# Police Department

## Town of Manchester-by-the-Sea ADA Transition Plan

March 2020

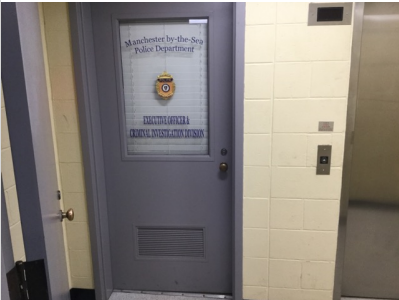
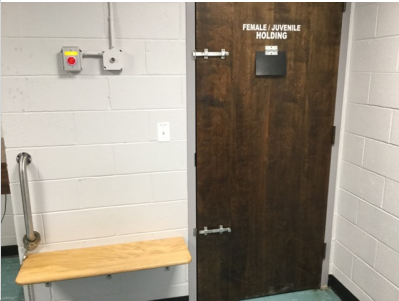
ID	Location	Floor	Room	Element	Type	Photo	Issues	Current Measure	Recommendations	Quantity	Price	Cost Estimation
Approach and Entrance												
Exterior Access Route												
1	Across From Seaside 1 Building	1		Exterior Access Route	Walkway		Route not maintained in operable working condition	-	Ensure the accessible route is maintained in operable working conditions.	1	-	\$0
2	Towards Main Entrance	Ext.		Exterior Access Route	Walkway		Cross slope > 1:50 (2.00%)	2.7%	Reduce cross slope to be no steeper than 1:50 (2.00%).	1	-	\$0
Entrance												
3	Main Entrance	Ext.		Entrance	Main Entrance		Entrance not on an accessible route Directional sign to accessible entrance not provided Mat not securely attached	<ul style="list-style-type: none"><li>-</li><li>-</li><li>-</li></ul>	Provide a directional sign indicating the location of the nearest accessible entrance. Secure the mat.	1	346	\$346
Access to Goods and Services

Means of Egress												
4	Emergency Exit	G		Means of Egress	N/A		Tactile exit sign not provided Emergency exit not on an accessible route Directional sign to accessible emergency exit not provided	<ul style="list-style-type: none"><li>-</li><li>-</li><li>-</li></ul>	Ensure a tactile exit sign with raised characters and braille is provided at exit door. Mount signs between 48"- 60" above finished floor located on the latch side of the door. Provide a directional sign indicating the location of the nearest emergency exit.	1	232	\$232

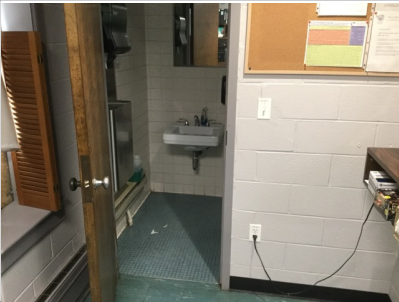
ID	Location	Floor	Room	Element	Type	Photo	Issues	Current Measure	Recommendations	Quantity	Price	Cost Estimation
5	Emergency Exit	G		Means of Egress	N/A		Tactile exit sign not provided Illuminated ISA symbol not provided (MAAB)	- -	Ensure a tactile exit sign with raised characters and braille is provided at exit door. Mount sign between 48"- 60" above finished floor located on the latch side of the door. Provide an illuminated sign with the International Symbol of Accessibility.	1	432	\$432
Interior Access Route												
6	Executive Officer	1		Interior Access Route	N/A		Route < 36" wide	-	Rearrange furniture to ensure that a clear width of 36" min. is maintained at the accessible route.	1	Labor	\$0
7	Police Station - Meeting Room	1		Interior Access Route	N/A		Route < 36" wide	29.5"	Rearrange furniture to ensure that a clear width of 36" min. is maintained at the accessible route.	1	Labor	\$0

Doors, Doorways, & Gates												
8	Police Station - Meeting Room	1		Doors, Doorways, & Gates	Meeting Room		Maneuvering clearance(s) not provided	-	Rearrange furniture to ensure that the maneuvering clearance is maintained at the door.	1	Labor	\$0
9	Police Station - Meeting Room	1		Doors, Doorways, & Gates	Office		Maneuvering clearance(s) not provided Door requires > 5 lbs. of force to open	- 7 lbs	Rearrange furniture to maintain the maneuvering clearance at the door. Adjust closers so doors do not require more than 5 pounds of force to open.	1	Labor	\$0
